Re: "In the Matter of Advanced
Television Systems and Their
Impact Upon the Existing
Television Broadcast Service."
MM Docket No. 87-268

Comments of the Firm of
du Treil, Lundin & Rackley, Inc.

Figure 1

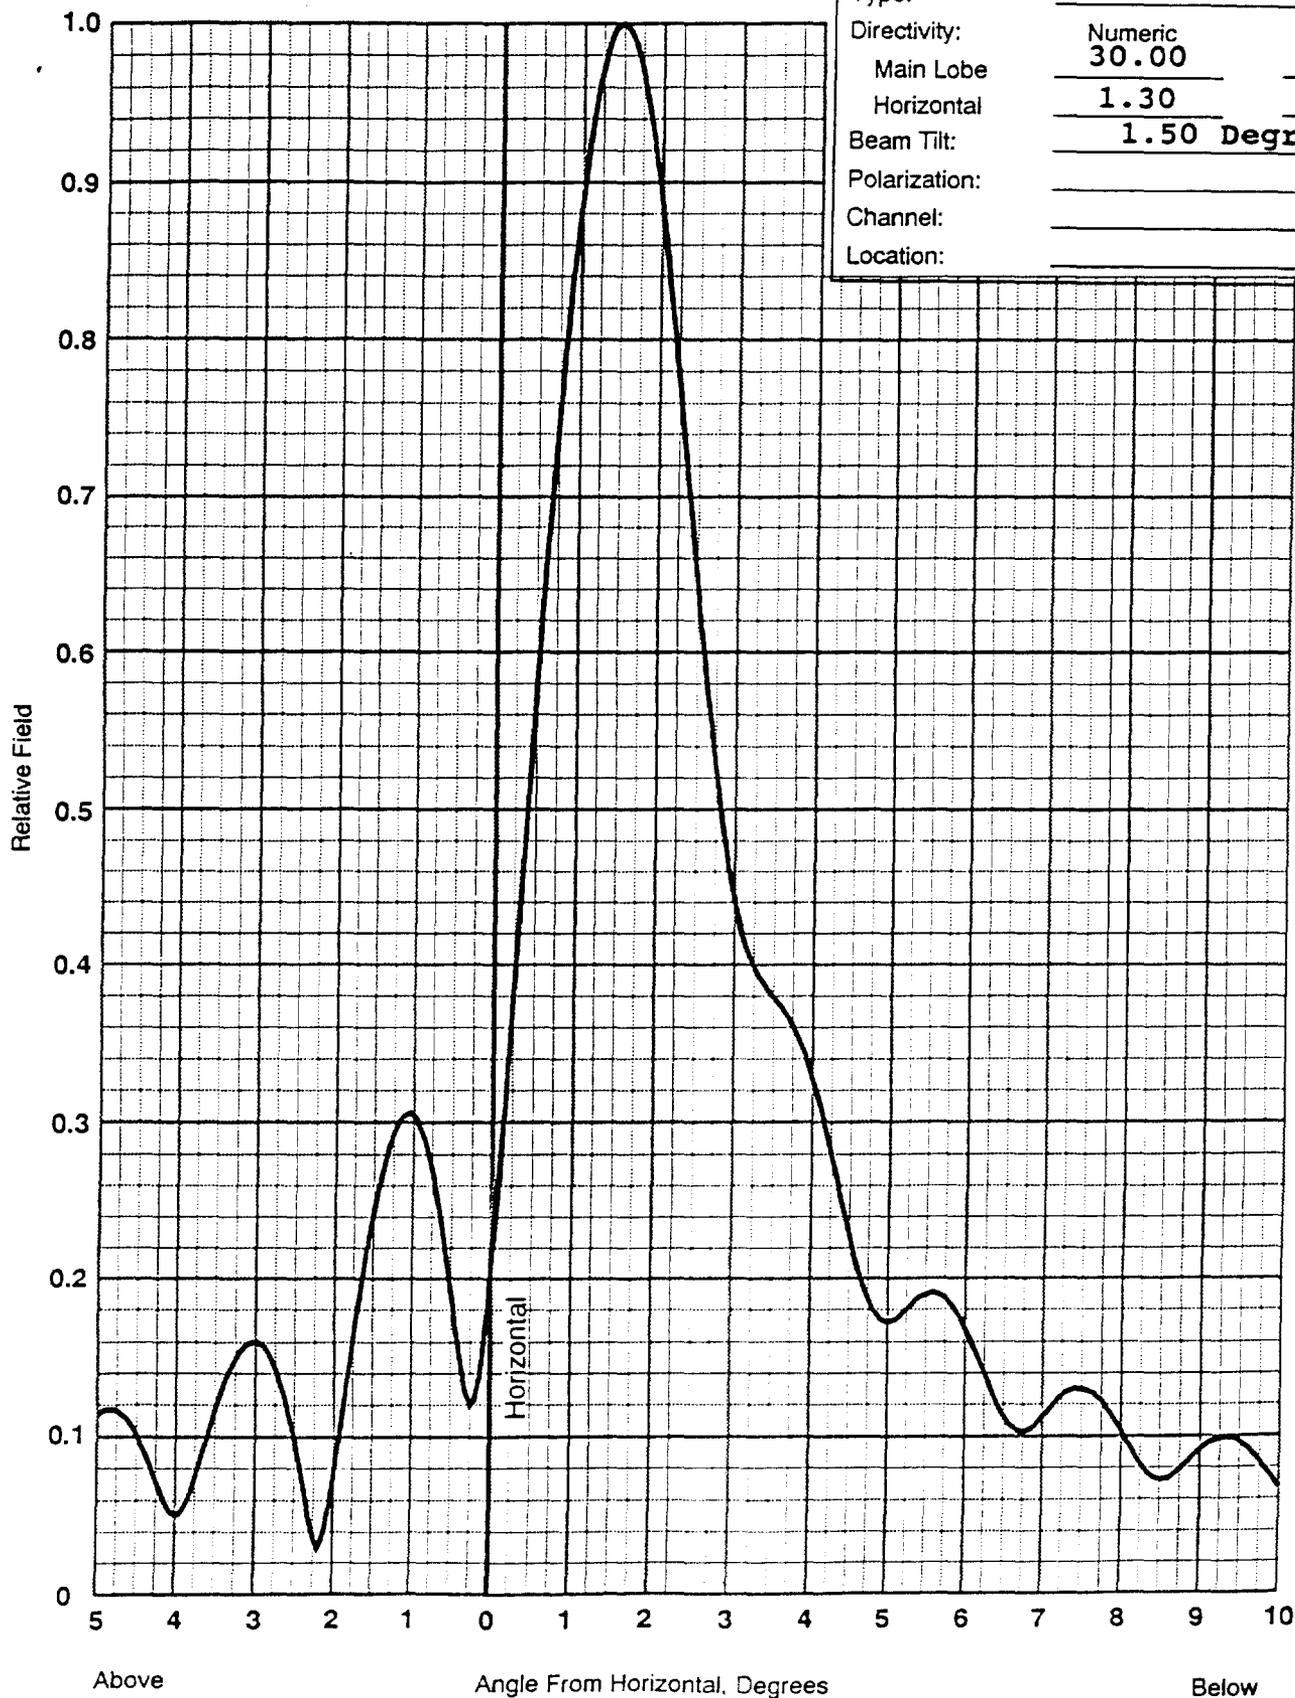
Current full service television interference calculations are based on the maximum ERP in a particular direction regardless of the antenna's beam tilt. This conservative assumption eliminates the need to consider the effects of tower and antenna plumb, and the antenna movements caused by wind. Prominent tower companies (Kline, Stainless, LDL) indicate typical tower deflections of 1 to 2% under normal loading and guying conditions. This equates to an antenna angular deflections of 0.57 to 1.1 degrees.

Figure 1 is included as an example of a vertical plane relative field pattern for a UHF antenna having typical gain. For this example, it is assumed that 0 degrees reflects the relative field (i.e., 0.224) to the radio horizon for a DTV station authorized an ERP of 50 kW (17 dBk) by the FCC. A maximum ERP of 1000 kW would occur 1.5 degrees below the horizon. We will ignore possible angular variations due to tower and antenna plumb. For a conservatively assumed tower loading deflection of up to 0.6 degree, the ERP in this example can vary from a low of approximately 14.5 kW (11.6 dBk) up to 410 kW (26 dBk). It is this potentially higher DTV ERP level (i.e., 9 dB in this case) at the radio horizon which can result in additional interference to pertinent analog and DTV operations. Furthermore, the higher ERP level at the radio horizon can result in an unwarranted extension of the station's service contour.
